Case number: **2020-002853-HDRB**
Project Type: HDRB

PROJECT LOCATION (S): 675 Alto Street

675 Alto Studio

Summary of Proposed Changes

A2.0
18 Elevations

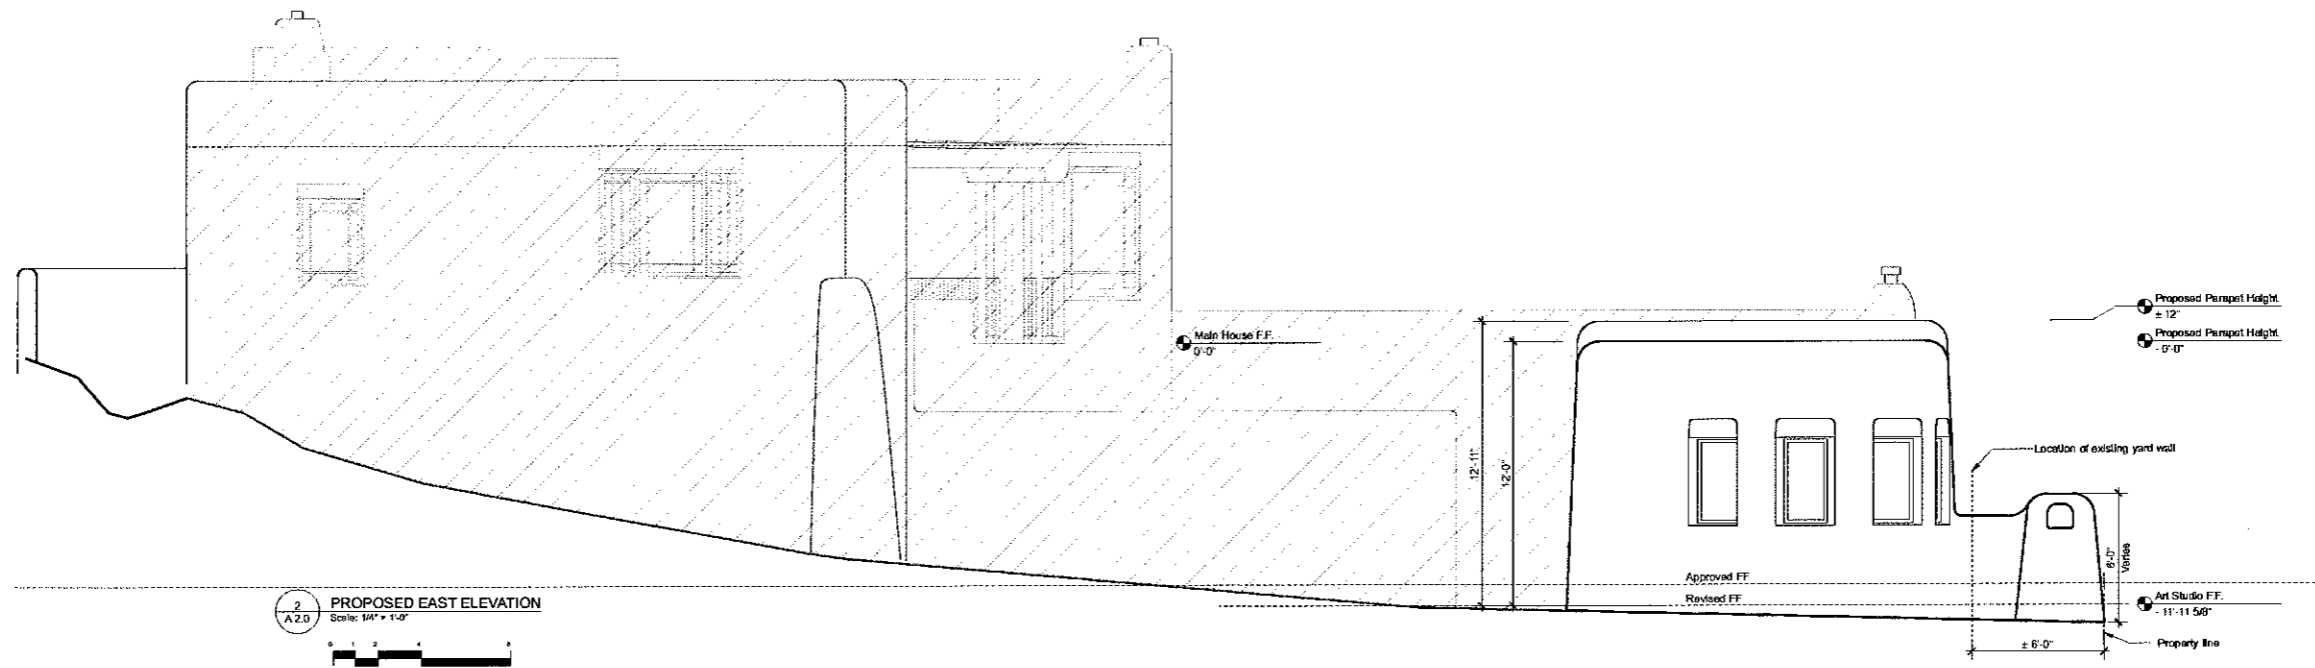
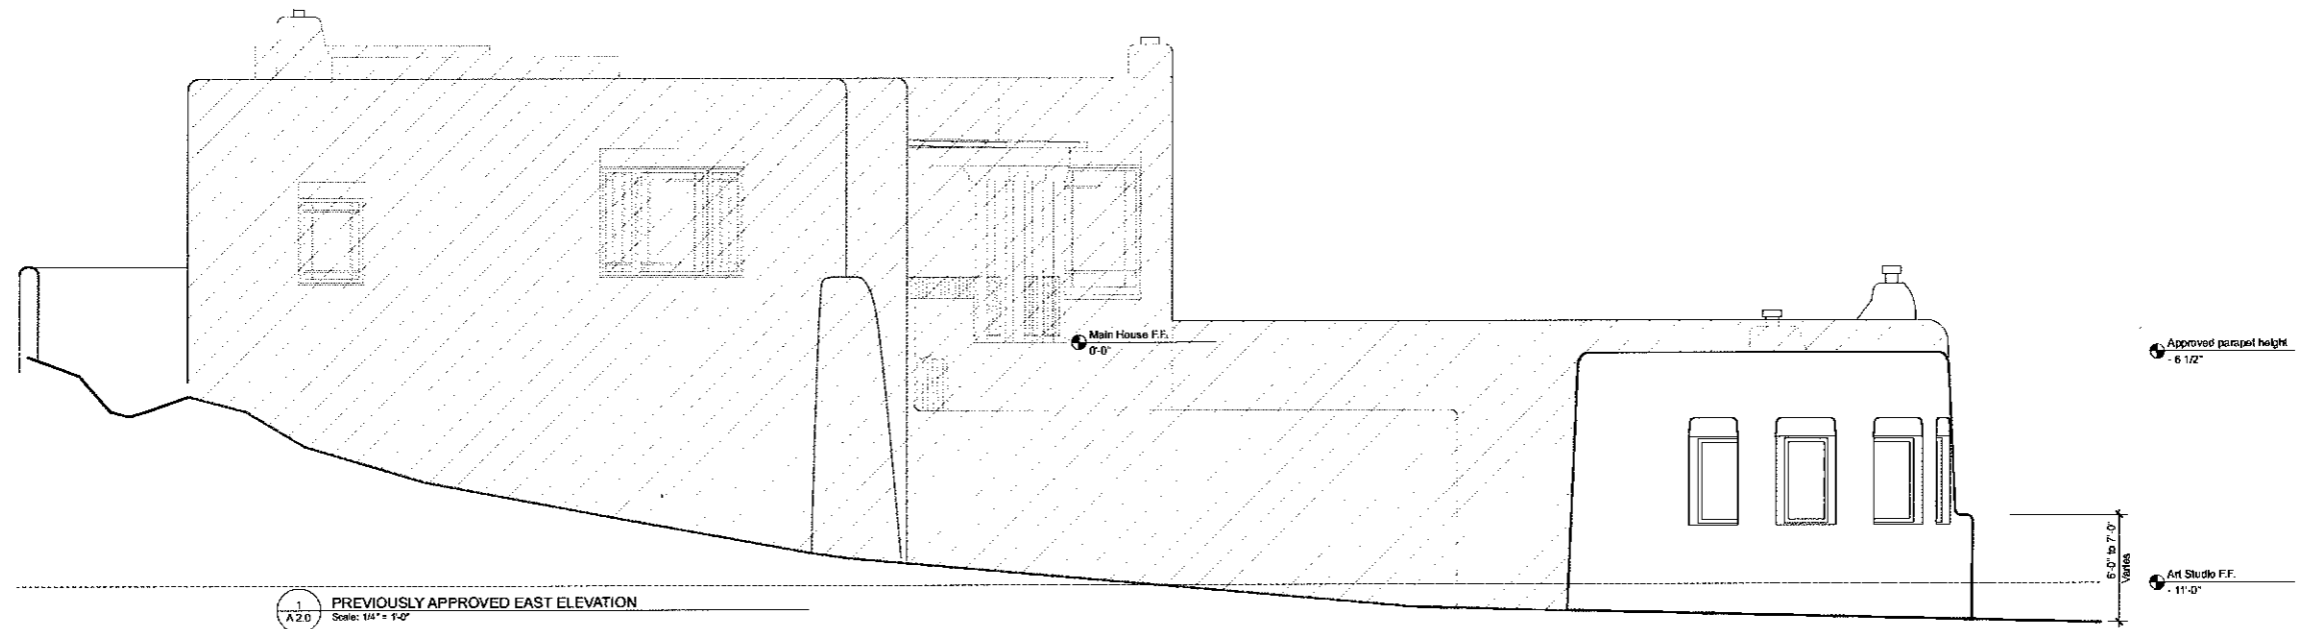
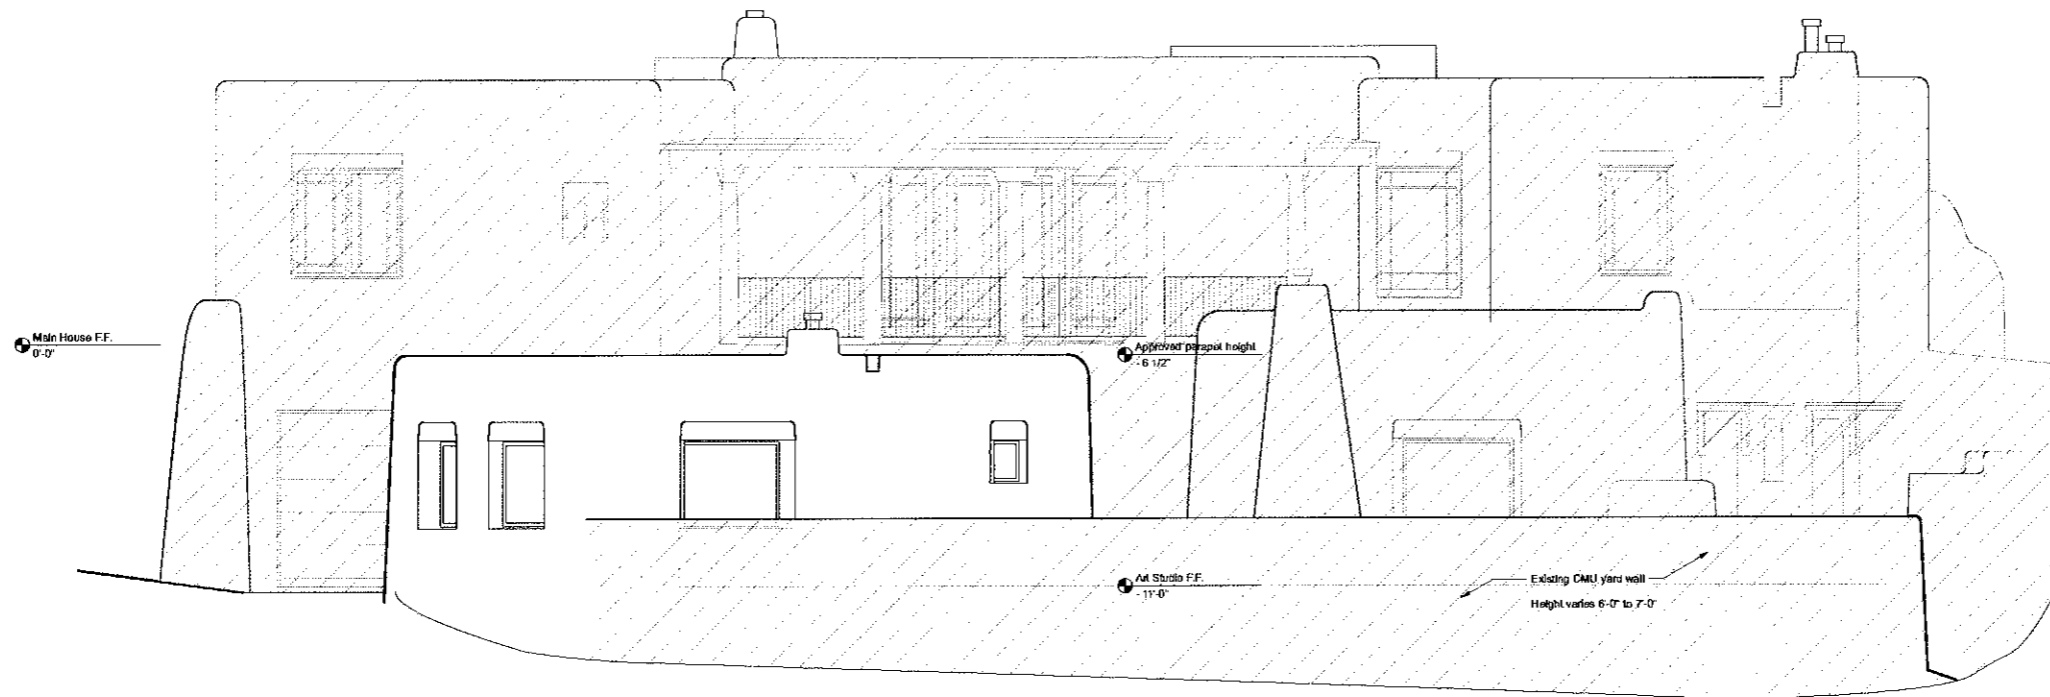
- 1) Remove existing CMU wall and replace with Adobe wall with decorative stone base.
- 2) Move existing yard wall approximately 6'-0" North into property line.
- 3) Lower yard wall height by 1'-0" to 5' except up to 6' at peak over 3 wall openings.
- 4) Lower finish floor level ± 12".
- 5) Remove fireplace and chimney.
- 6) Stop parapet and raise parapet height by approximately 10" in two steps.
(Change due to Viga thickness and BUR requirements).

Oct 12, 2020 revised Nov 19, 2020
Proposed Revisions
Documents
A2.1
19 Elevations

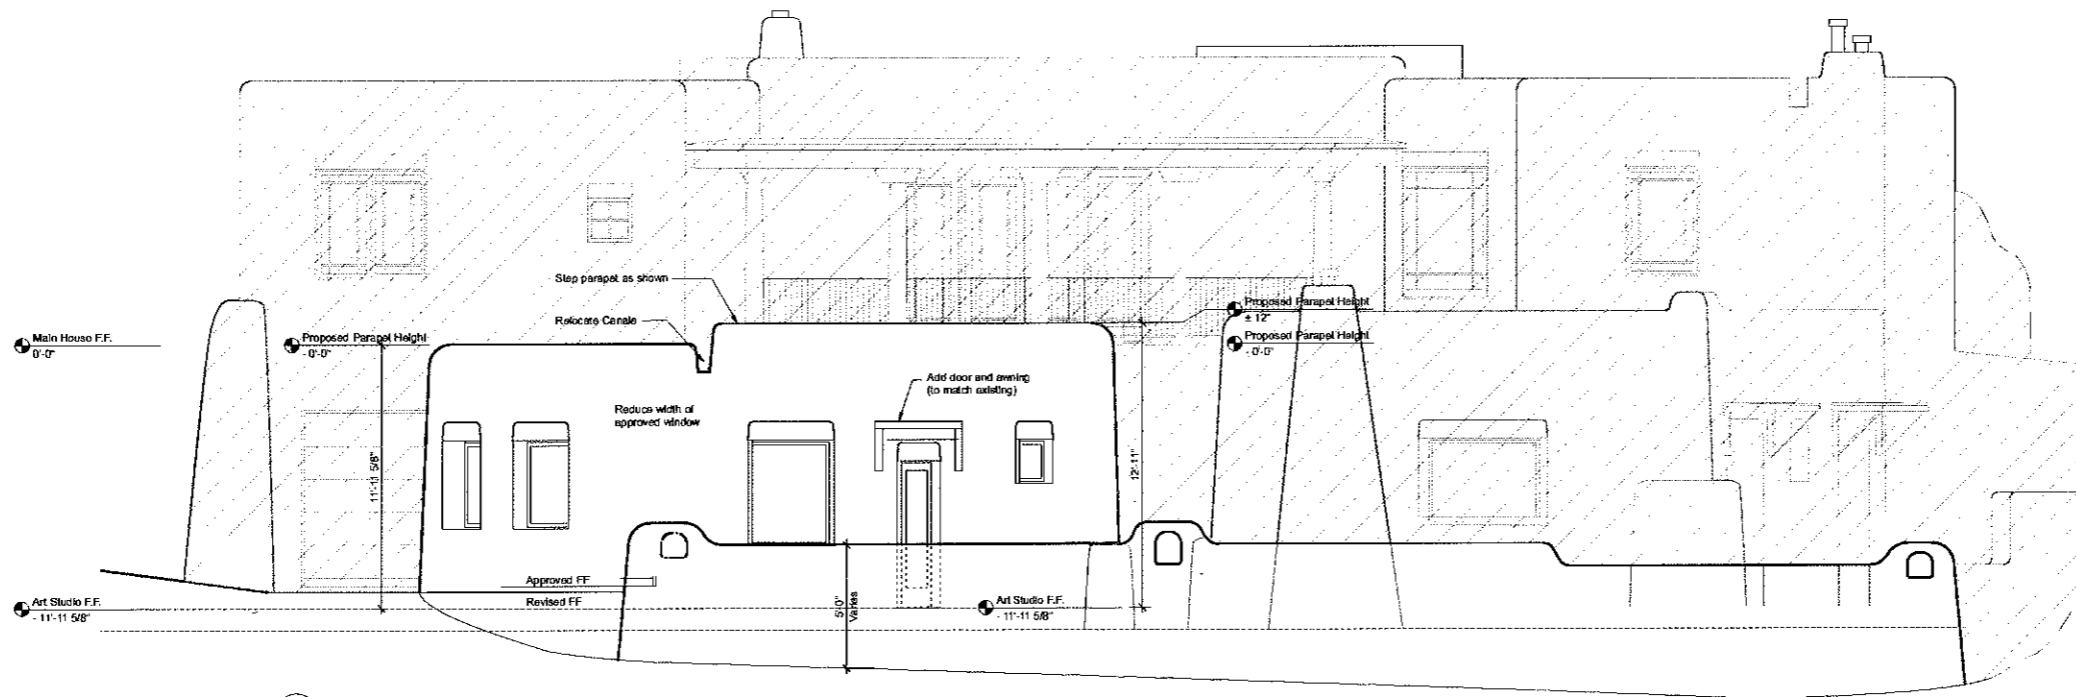
1 PREVIOUSLY APPROVED NORTH ELEVATION
Scale: 1/4" = 1'-0"

2 PROPOSED NORTH ELEVATION
Scale: 1/4" = 1'-0"

A2.2
20 Elevations

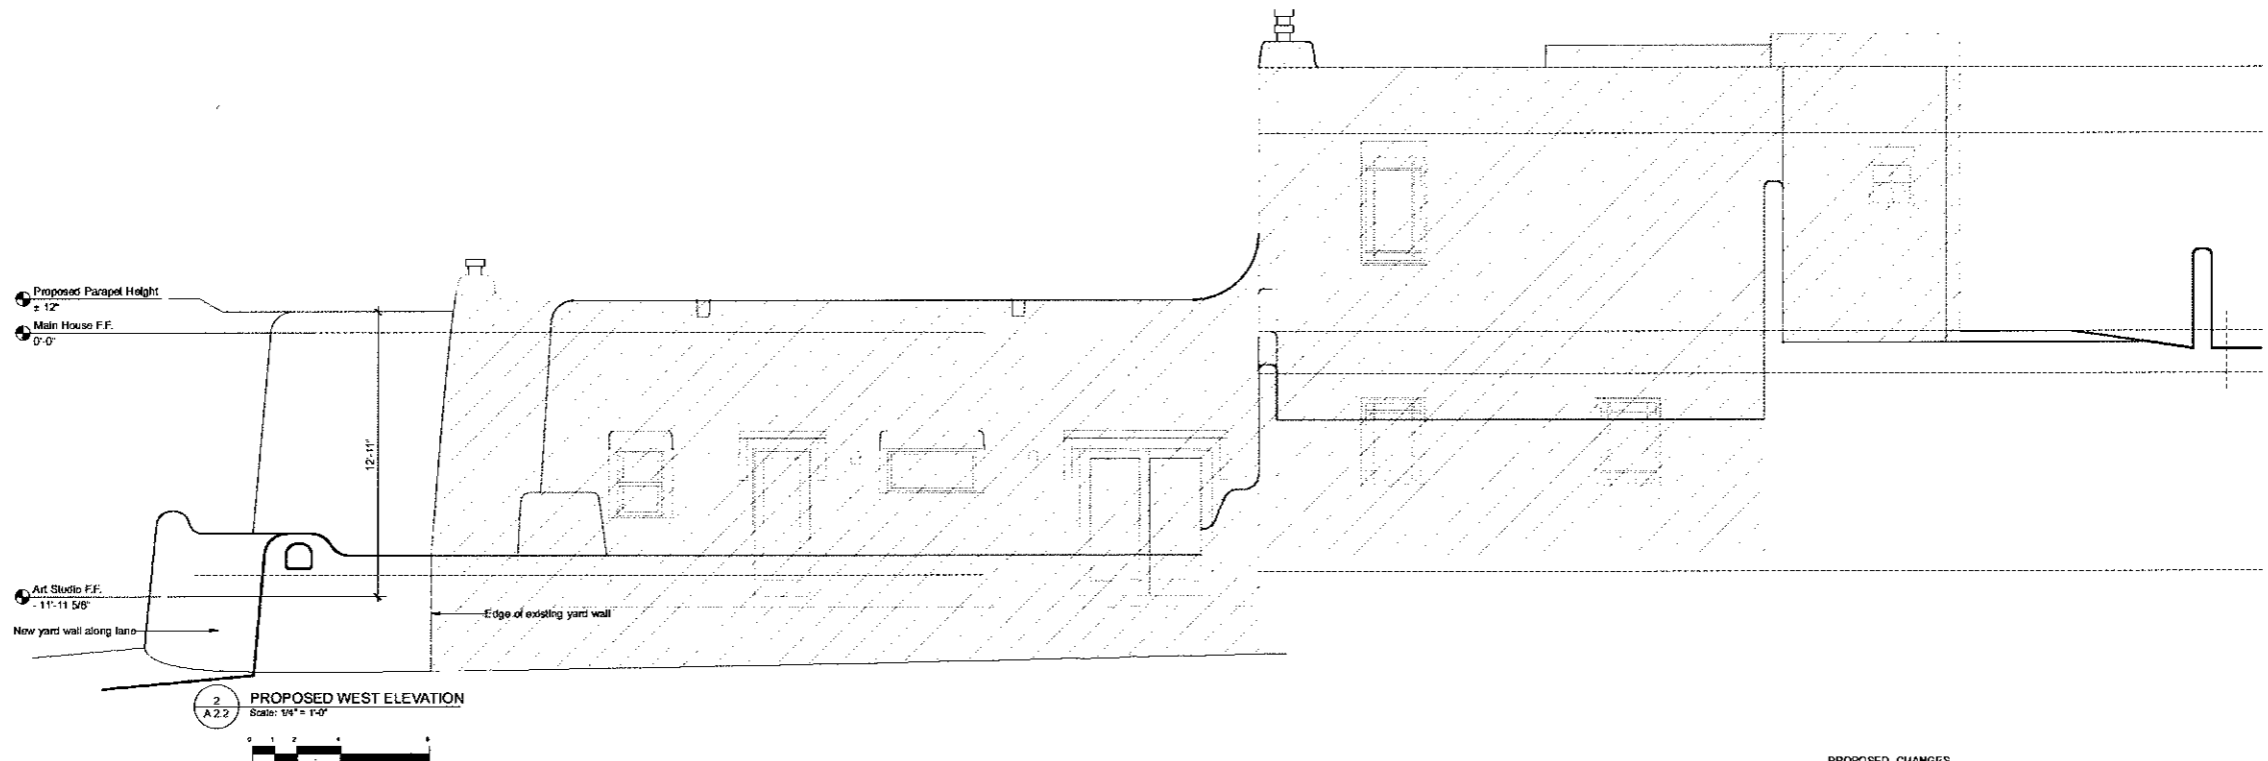
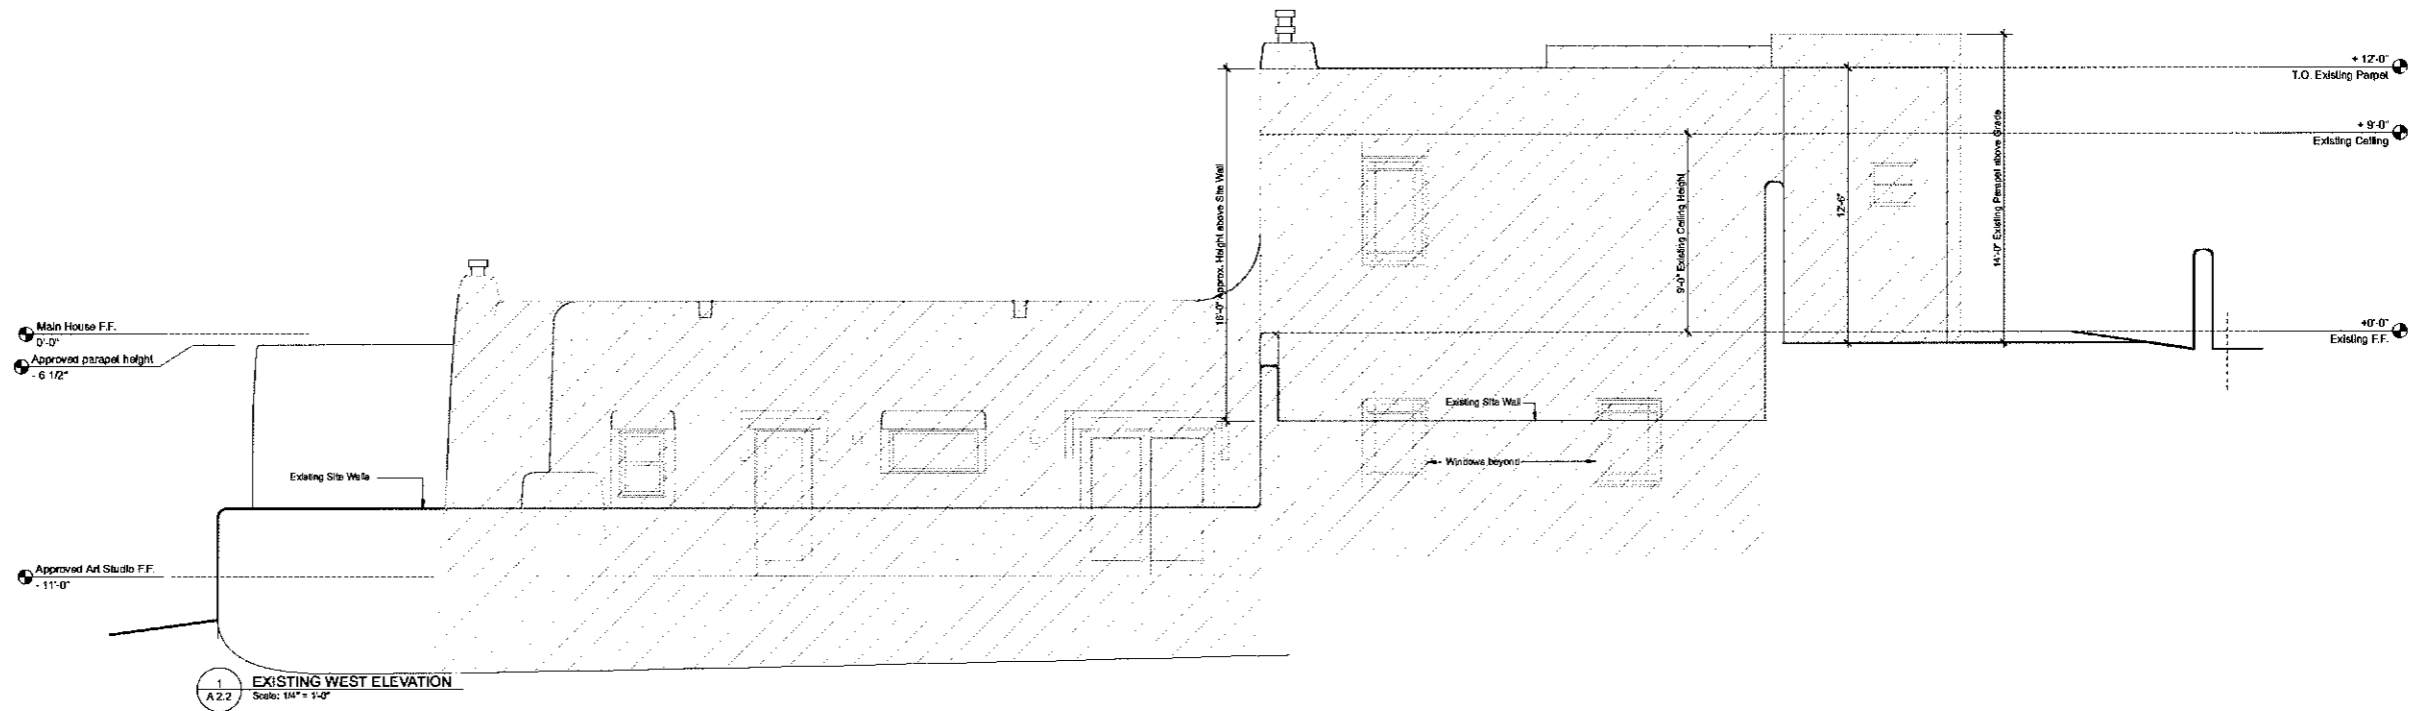
- 1) Remove existing CMU wall and replace with Adobe wall with decorative stone base.
- 2) Move existing yard wall approximately 6'-0" North inside property line
- 3) Lower yard wall height by 1'-0" to 5' and up to 6' at the peak of the 3 openings
- 4) Lower finish floor level ± 12"
- 5) Remove fireplace and chimney
- 6) Step parapet and raise parapet height by approximately 18" in two steps.
(Change due to Viga thickness and BUR requirements)
- 7) Add door and awning
- 8) Modify dimensions of North window
- 9) Relocate canale

- PROPOSED CHANGES
- 1) Remove existing CMU wall and replace with Adobe wall with decorative stone base.
 - 2) Move existing yard wall approximately 6'-0" North inside property line.
 - 3) Lower yard wall height by 1'-0" to 5' except up to 6' at peak over 3 wall openings.
 - 4) Lower finish floor level ± 12".
 - 5) Remove fireplace and chimney.
 - 6) Step parapet and raise parapet height by approximately 18" in two steps.
(Change due to Viga thickness and BUR requirements)
